North Hertfordshire District Council

Building Conservation comments

File Ref: 24/02060/FPH & 24/02061/LBC

Address: Julians, Julians Park, Rushden, Buntingford, Hertfordshire, SG9 0TD

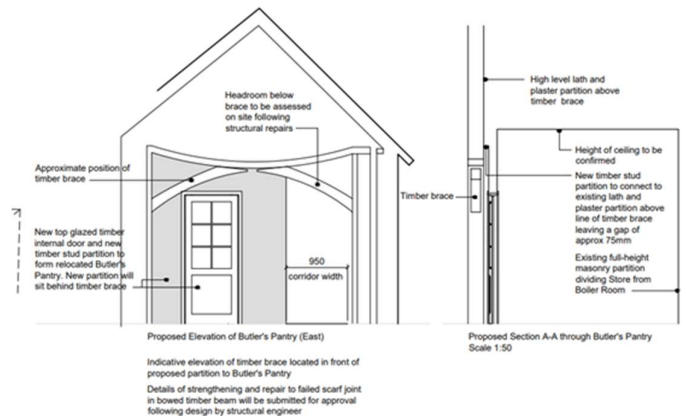
- 2.6 At 2.8 of my previous comments I referred to various internal doors and stated the following:

Whilst I made no mention in my previous comments to whether these doors should be retained or not, there is arguably a case to retain the character of the Butler's Pantry Corridor. In so doing potentially doors D1 and D5 could be retained in-situ. If the applicant was seeking a uniformed approach to doors off the kitchen then I am appreciate that my suggestion would not achieve this.

I continued by saying at 2.10:

To address SPAB's objection to the proposed interventions within the Butler's Pantry Corridor, consideration could be given to retaining existing doors, cupboards, and panelling. I appreciate that I previously stated a "consequence of removing the C20 partitions forming the Butler's Pantry/Laundry, the amended layout provides the opportunity to reinstate the C17 fireplace and bressummer beam to the proposed kitchen and dining area". However, I can be convinced of an alternative approach offered by SPAB which is to do less, and I am not entirely convinced that to reinstate an overmantle in what would be an opened-up space adjacent to the external doorway leading to the Butler's Pantry Corridor is fully justified. Not interfering with this space would enable two existing doors to also be retained in-situ (see 2.7).

- 2.7 Consequently, the partition to the service corridor and door D1 are to be retained in-situ.
- 2.8 Previously, I queried as to how the timber braces in the images below relate to new fabric and that internal elevations would be welcome as part of a formal submission. An internal elevation was provided but lacked the clarity of detail to be able to make an informed decision without imposing a condition.

4.0 Proposed Elevations – drawing no. 2309/PD/204 Rev L

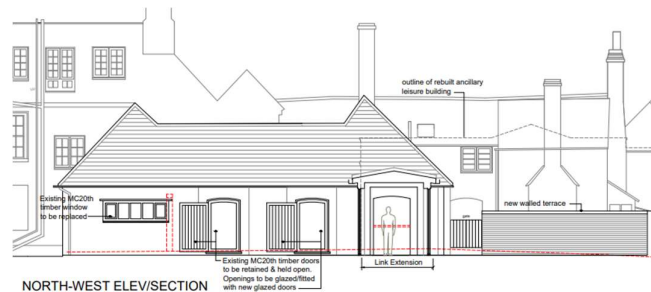
4.1 Previously SPAB considered the introduction of fully glazed doors to the south elevation to be 'problematic' and encouraged the applicant to consider a design that incorporates smaller glass panels within a timber frame if there is a need to introduce more light to the internal space. SPAB were also not convinced that the rehanging of the historic doors onto parliament hinges would work well in practice.

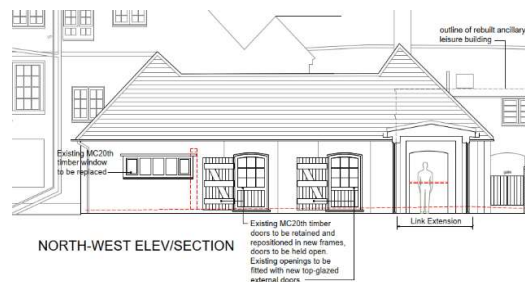
An alternative was offered (see below) to which I gave the following feedback:

In my opinion, either the existing doors are pinned back as shown but with simple glazed doors in the openings or omitting the mid C20 timber doors and just having the part-glazing doors as shown for which I am happy with the design thereof. This then brings me on to your third point as to whether the existing mid C20 doors can be reused elsewhere. If suitable locations can be identified for their reuse i.e. maybe the garage block, then this may be the way forward.

4.2 It is considered that the final version (see below) is unobjectionable.
